CONSTRUCTION GENERAL PERMIT SITE INSPECTION REPORT LEVEL 2 (COMPREHENSIVE)

Louisa Solar (Virginia Electric & Power Co).

CONSTRUCTION GENERAL PERMIT SITE INSPECTION REPORT REQUEST FOR CORRECTIVE ACTION

CONSTRUCTION GENERAL PERMIT SITE INSPECTION PHOTO LOG

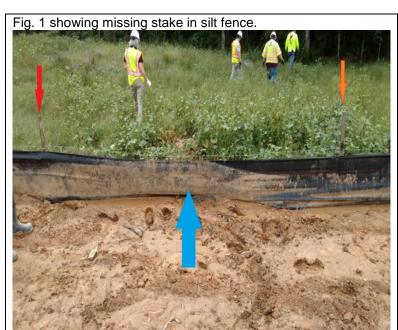
- 1. Silt Fence (Fig 1 & 2): DEQ observed a section of silt fence that was not properly staked in accordance with standard and specification 3.05. It appeared that the staking of this section of silt fence was more than six feet in length. Note: DEQ observed what appeared to be a sediment discharge in the area the silt fence appeared to be intended to protect. Note: Site staff corrected this deficiency before DEQ departed the site.

Fig. 2 showing sediment release behind silt fence shown in Fig 1.
